2116 4TH AVENUE
SEATTLE, WA

DESIGN RECOMMENDATION MEETING
DPD #: 3009145

DECEMBER 16, 2008

WEBER THOMPSON

SITE CONTEXT: VIEW DIAGRAM (EDG)

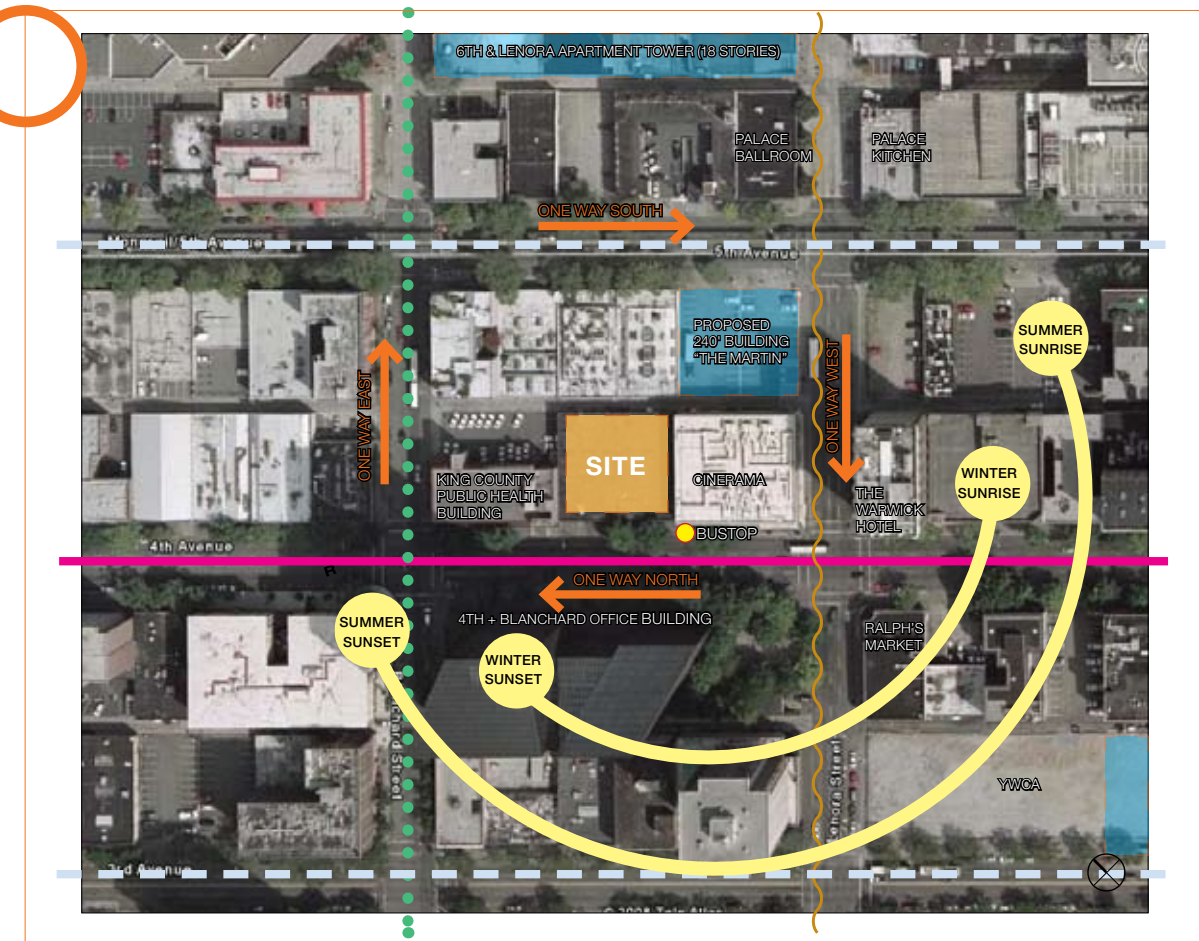
The Board discussed the street grid at this location and complimented the proposed massing for responding with angles to maximize views to and from the site.

The Board recognized that the proposed tower will be highly visible against the downtown skyline. They also mentioned they would like to see greater contextual analysis that extends far enough to show other towers potentials (existing and proposed) in the vicinity, as well as show what the permitted zoning would allow in the area. The Board encouraged the design to relate the top and the base to each other to form a cohesive whole.

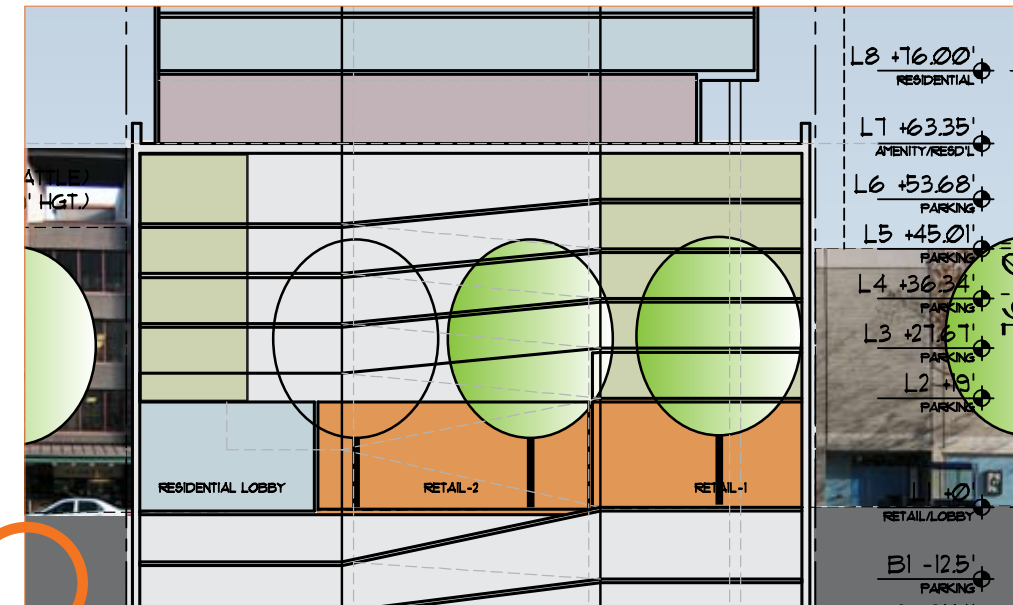
The Board discussed the shape of the proposed tower and was pleased with the tall, slender tower proportions under consideration. They noted to avoid the tendency to make the design overly fussy, but rather keep the design simple. Of the three massing alternatives, the Board agreed that Option 3 is preferred in terms of addressing glazing opportunities on the north and south elevations.

PROPOSED BUILDING SECTION (EDG)

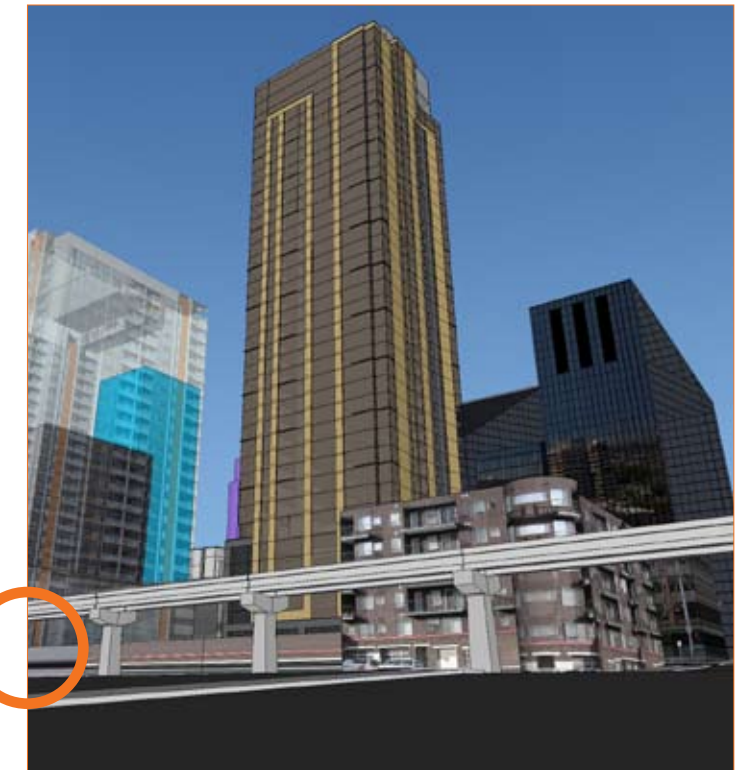
The Board emphasized that the tower design needs to be well integrated into the design of the podium base. The measures used to screen the above grade parking levels are a critical component of this integration. The Board noted that the proposed frame elements may not be necessary and risk becoming overly busy.

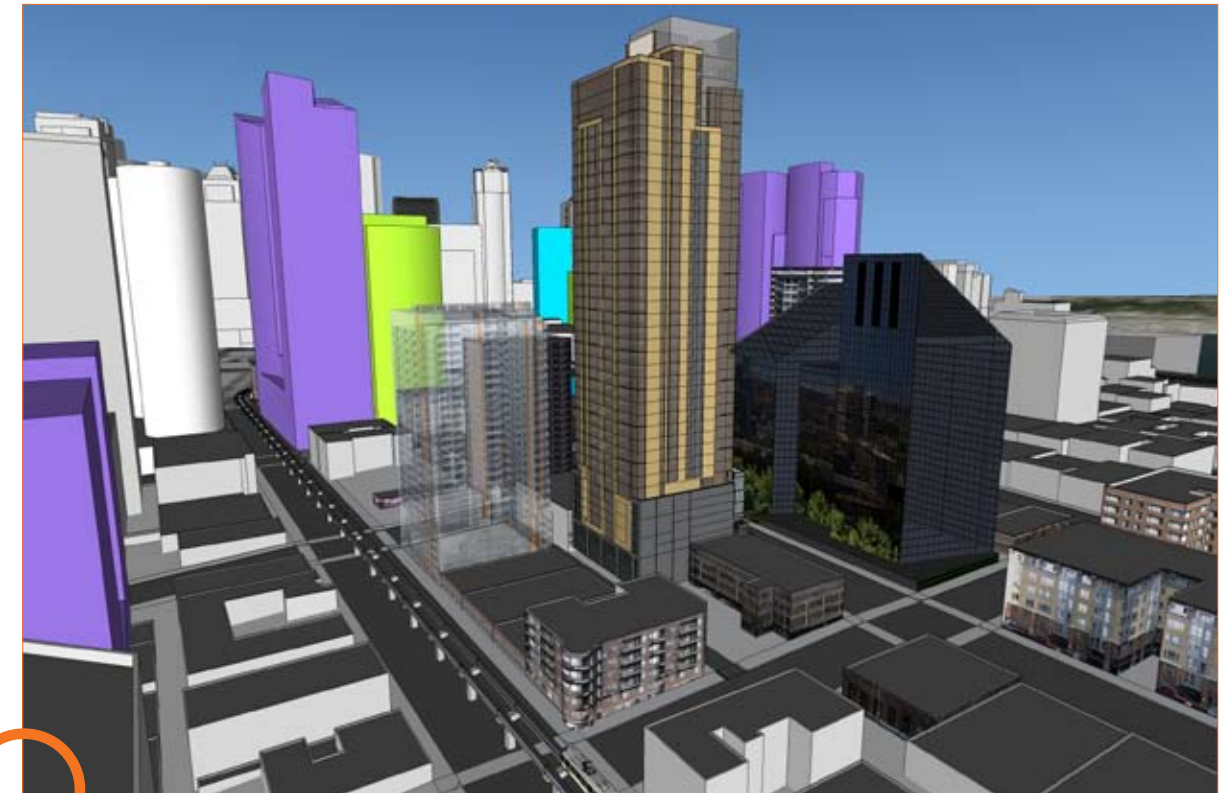
The Board was pleased with the efforts to minimize blank walls along the north and south facades and encouraged further development of this objective.

The Board noted a desire for continuous overhead weather protection along the street facing facade.

The Board was very supportive that all service functions are proposed from the alley. The Board noted that the alley facade will be quite visible and great care should be taken to further develop this elevation, especially given the tower separation rules and likelihood that the east elevation will continue to be visible from the surrounding area.

PROPOSED TOWER CONCEPT: STREETScape LANDSCAPE (EDG)

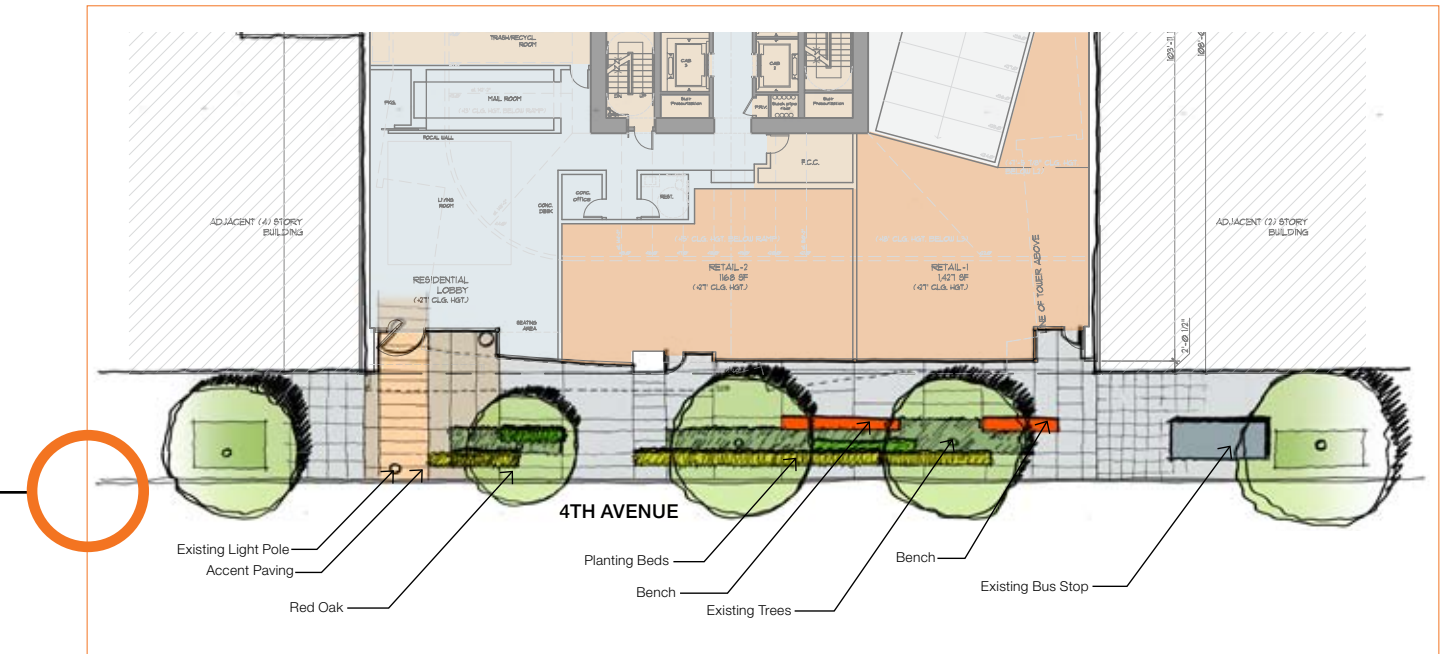
The Board encouraged the landscape design to allow for and enhance the pedestrian experience of those standing in lines associated with the next door Cinerama theatre.

The Board was pleased with the streetscape concepts presented at this meeting and supported the more linear designs.

The Board was pleased with the conceptual streetscape improvements studies and encouraged the streetscape design to allow opportunities for the retail use to spill over onto the sidewalk, keep a wider sidewalk, include street furniture and potentially create discreet separate area for pedestrian interaction. Of the six streetscape studies presented, the Board felt that the curvy lines were too distracting and preferred the more linear designs. Also, there are two existing street trees and some discussion of whether to add a third tree in front of the proposed residential entrance. The Board suggested that the either a tree or piece of artwork to signify and reinforce the entry point is desirable. The Board was pleased with the early concepts for the proposed amenity spaces – both interior and exterior.

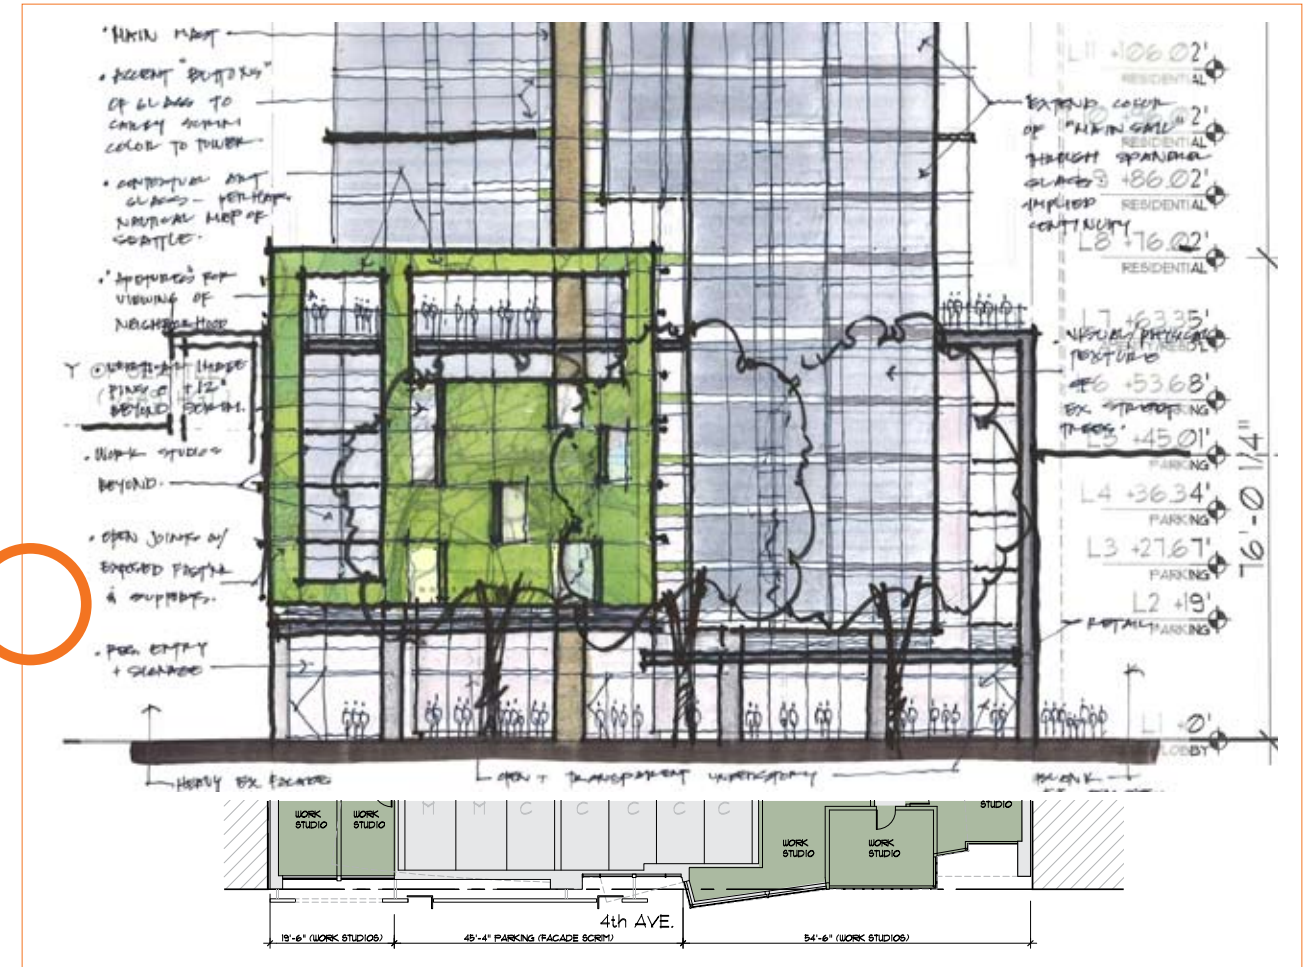
The Board applauded the studies of various design approaches to minimize the presence of parking along these facades. The Board felt the first screen option was too stiff and they expressed a preference for the second and third alternatives. There was concern with the placement and dimensions of the screen element with relation to the above grade parking. Dividing the screen directly in half appears awkward. The Board stressed that the screen should both reinforce the residential entry with a strong vertical announcement and relate to the mass at the building top to help integrate this element into the overall building architecture. The Board warned against drawing too much attention away from the tower and towards the screening of the above grade parking uses. As shown, there is too stark of a contrast between the tower and the screening element.

The Board encourages further exploration of the materials and screening design and noted that consideration of how the screening appears both during the day and night is important, especially as it relates to the overall building design.

DEPARTURE #2: 2116 4TH AVENUE (DPD #3009145)

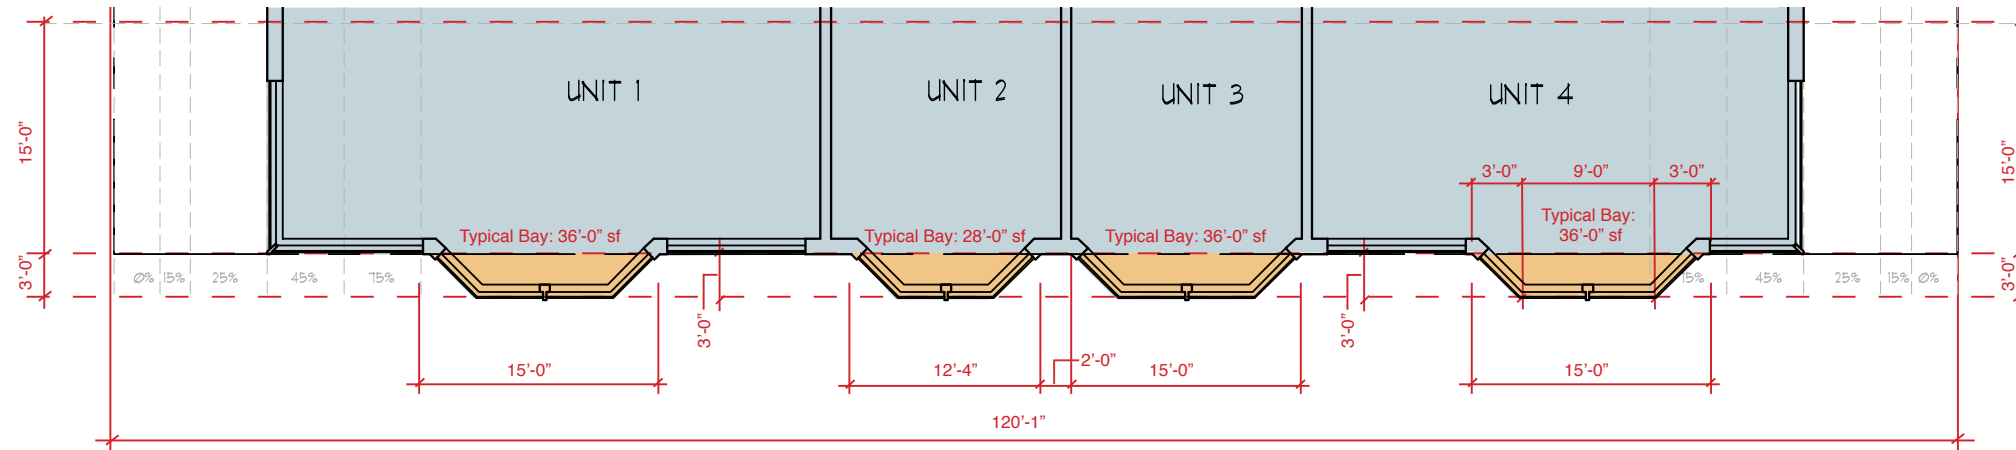
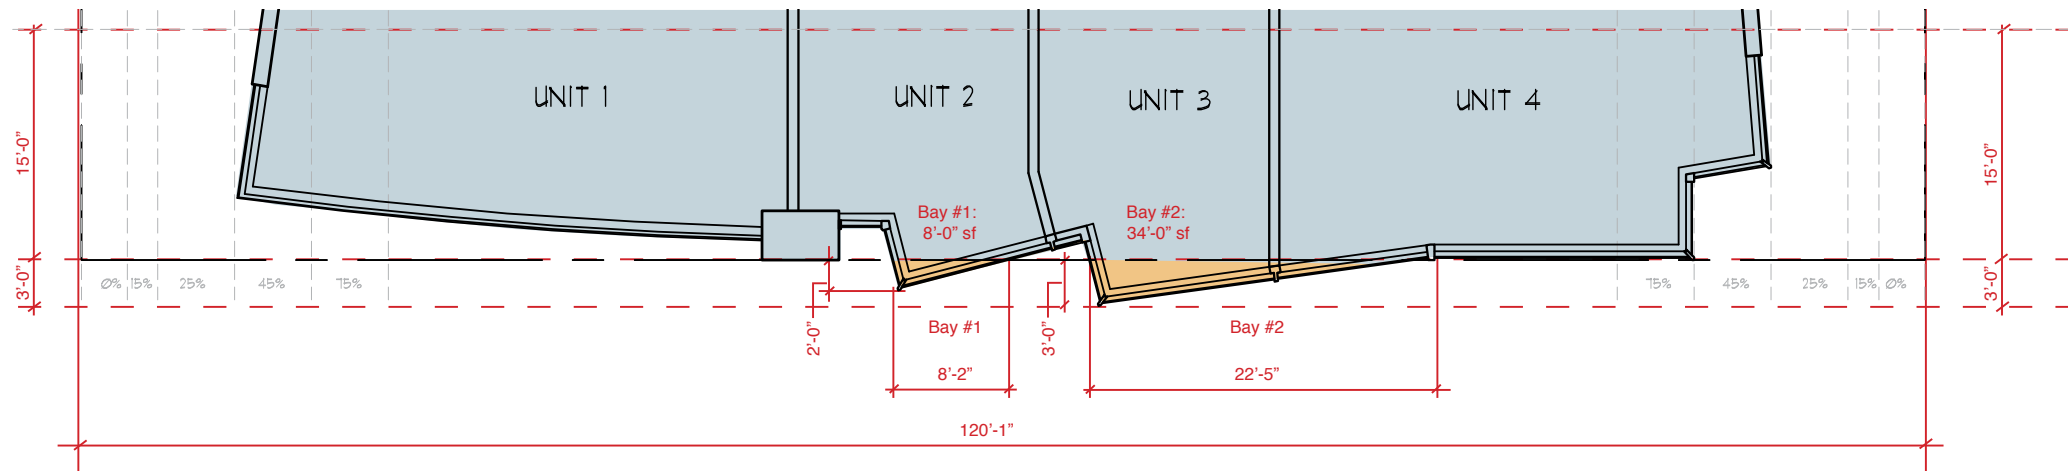
ITEM #	DEVELOPMENT STANDARDS	REQUIREMENT	PROPOSED	CONSIDERATIONS
2.	23.53.035.A.4 STRUCTURAL OVERHANG	Vertical bay (projecting) windows that increase either the floor area of the building or the volume of space enclosed by the building above grade, shall be limited as follows: a. The maximum horizontal projection shall be three (3) feet. b. The glass areas of each bay window shall not be less than fifty (50) percent of the sum of the areas of the vertical surfaces of such bay window above the required open area. At least one-third of such required glass area of such bay window shall be on one (1) or more vertical surfaces situated at an angle of not less than thirty (30) degrees to the line establishing the required open area. In addition, at least one-third of such required glass shall be on the vertical surface parallel to, or most nearly parallel to, the line establishing each open area over which the bay window projects. c. The maximum length of each bay window shall be fifteen (15) feet, and shall be reduced by means of forty-five (45) degree angles drawn inward, reaching a maximum of nine (9) feet along a line parallel to and at a distance of three (3) feet from the line establishing the open area.	Bay #1 (at Unit #2) projects 2'-0", and then tapers back to the property line with a total proposed length of 8'-2". The proposed length and projected distance of Bay #1 is within the code allowable limits (15'-0" and 3'-0" respectively), but differs in shape from the traditional bay window as defined by the code (see Diagram #1). Bay #2 (at Units #3 + #4) projects 3'-0", and then tapers back to the property line with a total proposed length of 22'-5". The proposed projected distance of Bay #2 is within the code allowable limit of 3'-0", but the proposed length and shape differs from the traditional bay window as defined by the code. Note: If the Board approves of the proposed "Scrim Facade", then it will be added to this "Structural Overhang" departure request.	The serrated shapes of Bays #1 + #2, as well as the tapering back to the property line, creates a more handsome solution to the traditional bay window shape, and also more effectively minimizes their perceived width.

The shapes and dimensions of the proposed bay windows allows for a better architectural solution to the code-described design, while also maintaining a less evident projection and less square footage in the R.O.W.
